ON-SITE SEWAGE DISPOSAL SYSTEM HOWARD COUNTY HEALTH DEPARTMENT BUREAU OF ENVIRONMENTAL HEALTH

SUBDIVISION: Bray Property (WHISPERING PINES) LOT NUMBER: 2

HOUSE LOCATION DRAWING

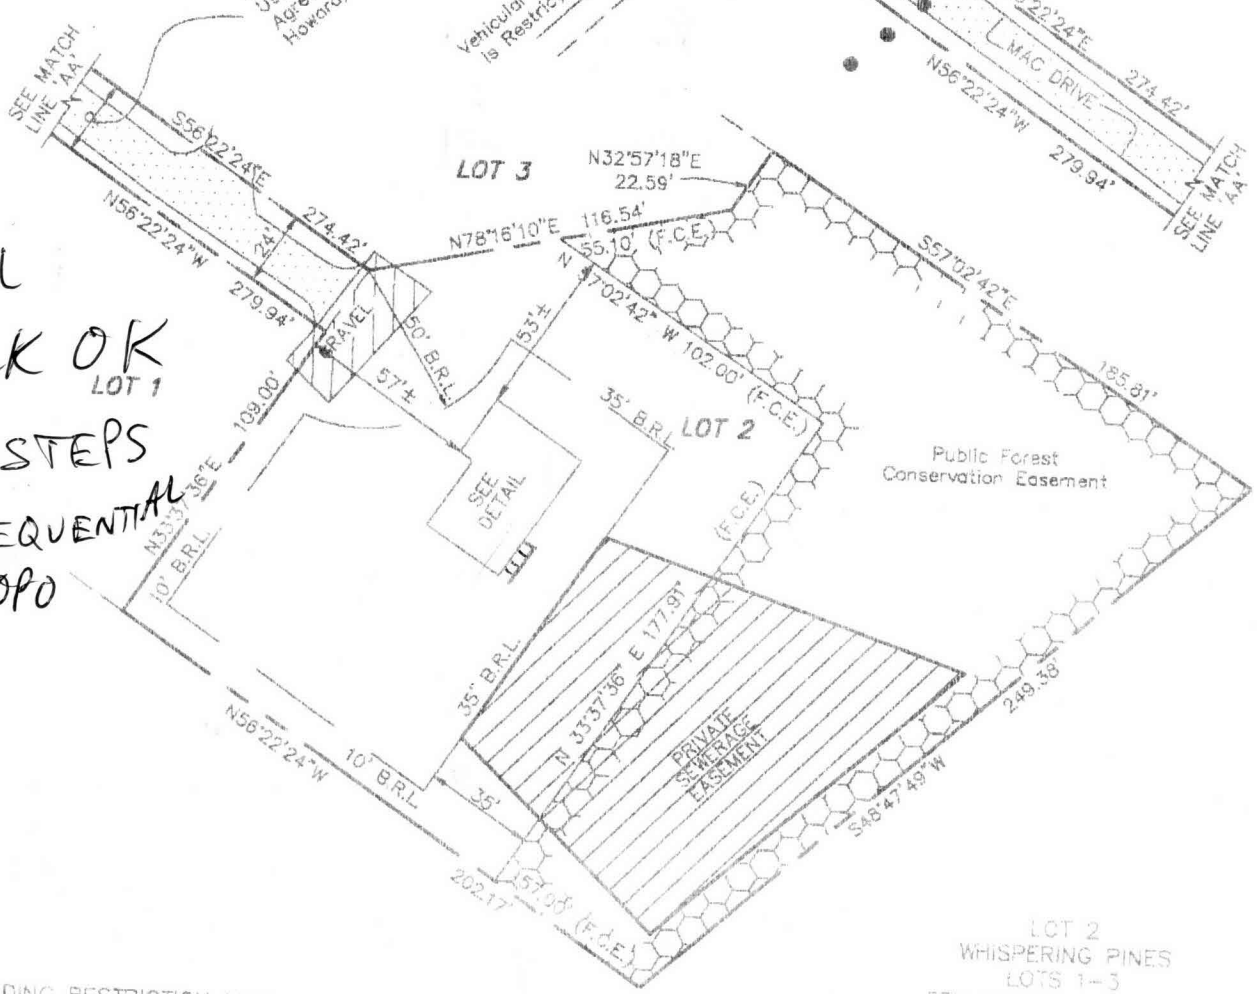
6/4/01 S.S. MODIFIED BY ALM FOR GRAVITY FLOW AND FUTURE PUMPING (MR)
 PRE-CONSTRUCTION INSPECTION: 6/13/01 - OK TO SET DBOX AS SHOWN ON REVISED BP PLAN

AND RUN TRENCHES IN BOTH DIRECTIONS, CONTOUR DIFFERENT THAN PLAN - (SRU)

6/5/01
WALL
CHECK OK
REAR STEPS
INCONSEQUENTIAL
DUE TO TOPO
ML

INSPECTION COMMENTS: 6/14/01 OK TO COVER (MR)
